Southwest Light Rail Transit: Kenilworth Shallow LRT Tunnels Water Resources Evaluation

Metropolitan Council

Project No. 76701

March 18, 2014

Figure 2: Construction Sheet Pile Cell

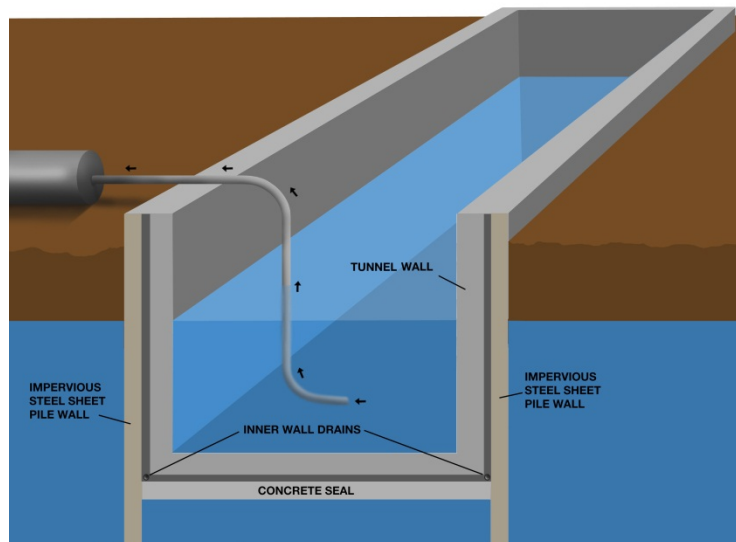
- Based on our understanding of the proposed construction method, the Cell 1 (Excavation) dewatering calculation would not apply because no pumping of groundwater would occur until after the excavation is complete and the concrete seal is in place. At that point the Cell 2 (Construction) scenario would apply.

- Although sealed sheet piling joints are proposed in the BODR, the analysis for groundwater control during construction of the excavation cells appears to assume open joints as stated in the BODR construction sequence.

- The calculation for groundwater removal in the excavation cell factors in the seepage rate for each sheet piling joint, the total number of joints, and the maximum precipitation anticipated to occur during the 15-day construction period. Additionally, this calculation factors in the volume of the cell that is below lake level during the 15-day period. However, when this volume is factored into the calculated pumping rate for the excavation cell a 45-day period is assumed. Groundwater removal from the excavation cell will occur in 15 days as that is the length of time the cell will be under construction. If the 15-day excavation cell period is substituted in place of the 45-day period, the resultant pumping rate is 24.6 gpm, rather than the 10 gpm reported in the BODR.

- For the Cell 2 (Construction) calculation (in which the sheet pile joints will be sealed) a joint resistance of 1.0×10^{-7} m/s is used. A joint resistance of 3×10^{-10} m/s should be used (according to the referenced sheet pile manual). When this factor is applied in the spreadsheet calculation, a pumping rate of 0.6 gpm is the result, rather than 2.4 gpm presented in the BODR.

- The source of the presumed rainfall amounts (6 inches for the excavation scenario and 12 inches for the construction scenario) was not stated. This would be a significant amount of rainfall and, therefore, would likely represent a near-worst case scenario for precipitation. It is recommended that the source of the precipitation amounts used in the calculations be stated.

It is recommended that these rates be thoroughly re-evaluated with clearly stated assumptions, input values, and ranges of calculated values. Additionally, the anticipated long-term performance of the waterproofing system should be evaluated considering its durability and other projects where this system has been used in similar settings.

Figure 6: Groundwater Piezometer Data (Voyen, 2013)

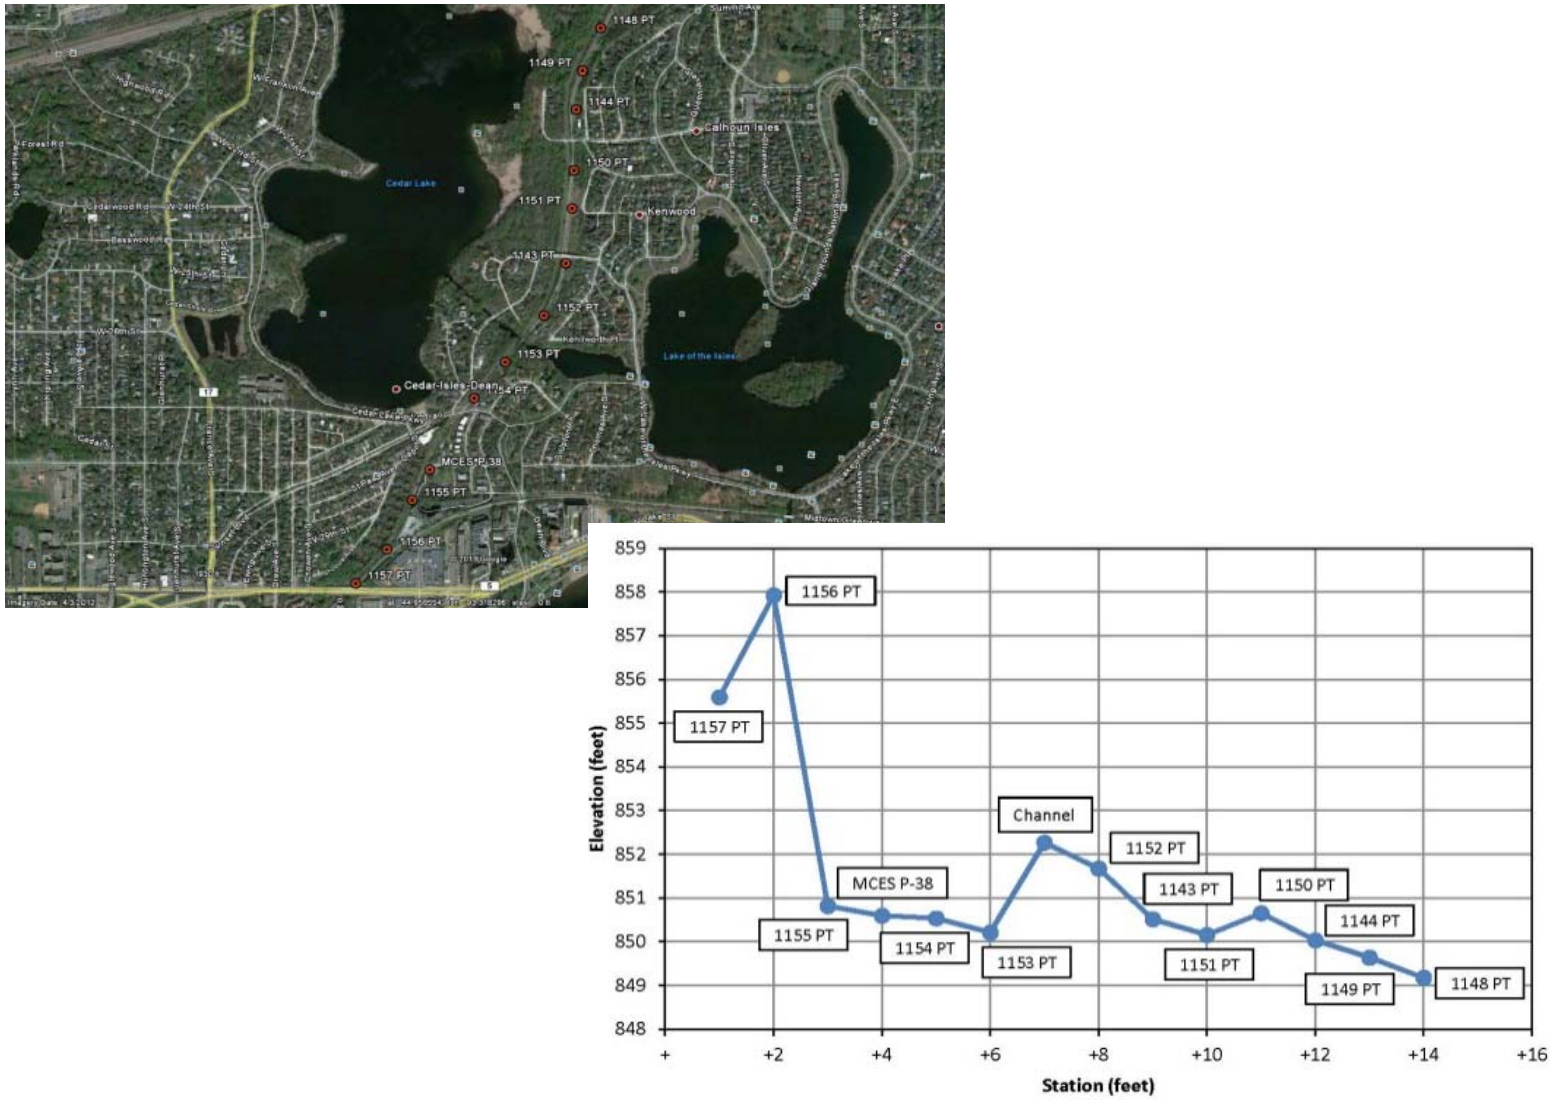
Since the AET piezometers are installed only along the proposed route in the Kenilworth Corridor, they only provide a one dimensional view of the groundwater elevations and it is difficult to conclusively determine the groundwater flow pattern. Additional piezometers lateral to the proposed route are needed to better characterize the groundwater flow system in two dimensions, and a few nested piezometers completed at a greater depth would help to evaluate potential downward flow. Also, the water levels presented in the BODR are only from October and November 2013. Seasonal water level data are needed to better understand groundwater elevations during wet periods and in response to rain events.

- Additional piezometers lateral to the planned route both north and the south of the channel are needed to better characterize the groundwater flow system in two dimensions. Also some sets of nested piezometers should be installed to evaluate vertical groundwater flow in the Kenilworth Corridor. This will help to better characterize and understand the direction and gradient of groundwater flow and the interaction between groundwater and surface water. Also, seasonal water level data are needed to better understand groundwater elevations during wet periods and in response to rainfall events.
